**CITY OF CARMEL-BY-THE-SEA  
CITY COUNCIL**

**RESOLUTION NO. 2023-099**

**A RESOLUTION OF THE CITY COUNCIL OF THE CITY OF CARMEL-BY-THE-SEA OVERTURNING THE JULY 2023 DECISION OF THE HISTORIC RESOURCES BOARD (RESO. 2023-009-HRB) AND ISSUING A DETERMINATION OF CONSISTENCY WITH THE SECRETARY OF THE INTERIOR'S STANDARDS, WITH NEW FINDINGS AND CONDITIONS, FOR THE CONSTRUCTION OF A MIXED-USE BUILDING WITH SUBTERRANEAN GARAGE ON A PORTION OF THE NORTHERN CALIFORNIA SAVINGS & LOAN COMPLEX SITE LOCATED AT DOLORES STREET 2 SOUTHEAST OF 7TH AVENUE IN THE SERVICE COMMERCIAL (SC) ZONING DISTRICT. APNS 010-145-012, 010-145-023, 010-145-024**

Figure 1. Preservation Buffer from Condition #2 illustrated in red. Build-to-Line waiver area from recitals is shown in yellow.

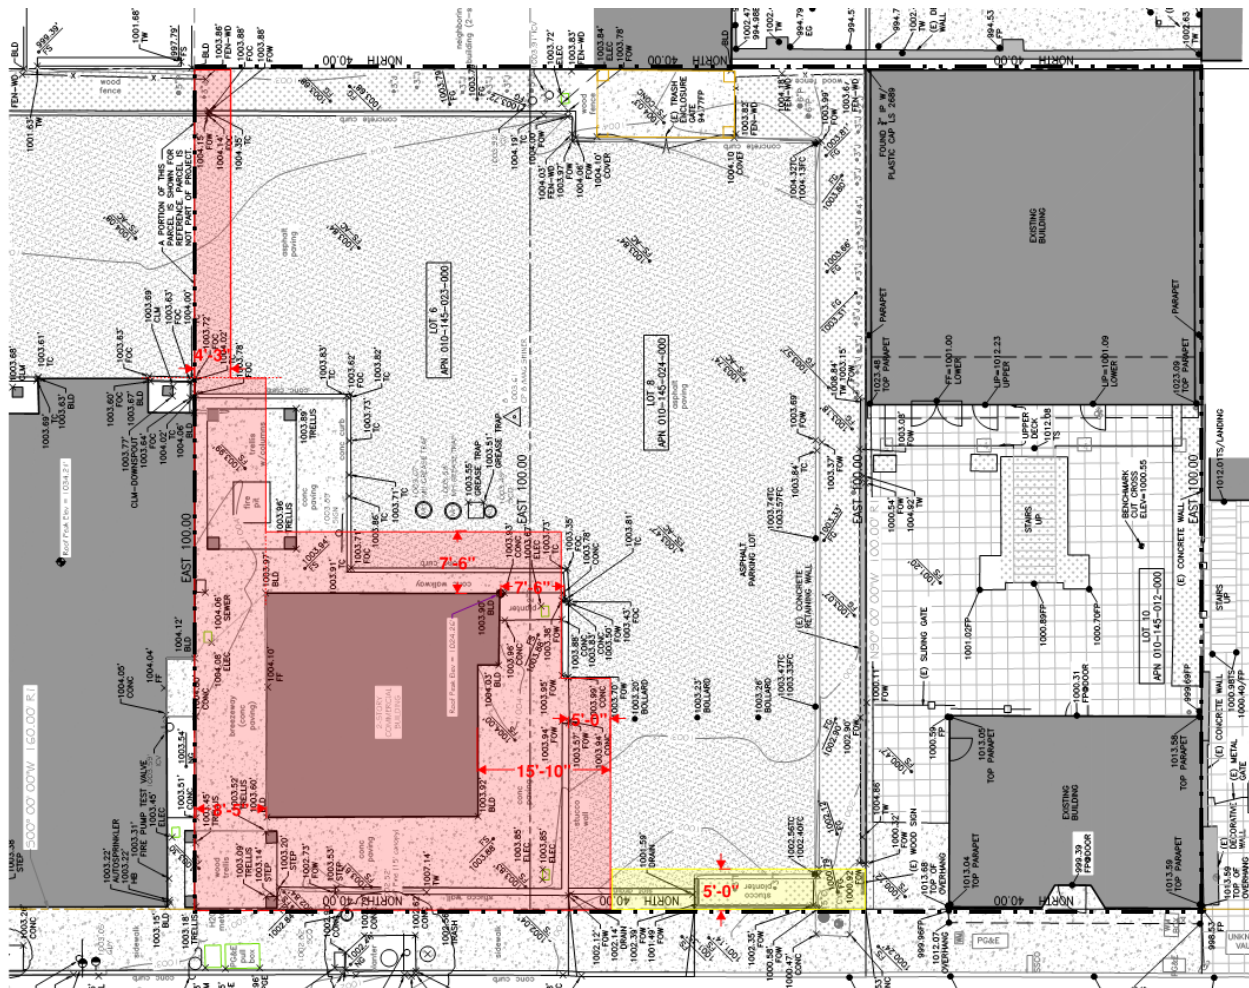
WHEREAS, the City Council hereby finds that to allow the remaining original intact portion of the ornamented concrete wall to be visible from the public right-of-way, a waiver from the build-to-line requirement (CMC 17.14.130) may be granted by the Planning Commission for portions of the proposed building located on Lot 8, for up to 5-feet from the property line. This waiver and creation of a Design Non-Conformity is granted in accordance with CMC 17.32.100.D, Benefits Available to Historic Resources on the Register and is intended to be a benefit to the applicant and not a mandated requirement; and

| <b>City Council Conditions</b>                               |   |
|--|---|
| 2.   | <b>Preservation of Spatial Relationships.</b> Prior to review by the Planning Commission, the Design Review plans shall be revised and submitted to the Community Planning and Building Department, to preserve the existing spatial relationship of the Northern California Savings and Loan Complex. At a minimum, all proposed structural elements shall be located outside of the Preservation Buffer as depicted in Exhibit A of this resolution. Walkways, at grade stairways, landscaping, paving, and similar features may be allowed within the Preservation Buffer, however, building elements that are defined as building coverage (CMC 17.14.130) shall not be permitted to encroach. Building eaves shall be limited to an encroachment of 18 inches or less.   |

The buffer includes:

- A minimum setback of 5' from the exterior of the original of the ornmented concrete wall;
- Maintaining the minimum separation around the community room on the south and east side as measured as the minimum distance from Community Room to the non-original (staff estimates 7'6" is the minimum distance from the Community Room to the non-original wall);
- Maintaining the minimum separation between the community room and the bank building (staff estimates this distance is 8'5"); and
- Keeping a 50% buffer of the minimum separation between the community room and the bank building from the northern property line adjacent to the Bank Building site (approximately 50% of the width of separation between the Bank Building and Community Room; staff estimates this distance is 4'3").
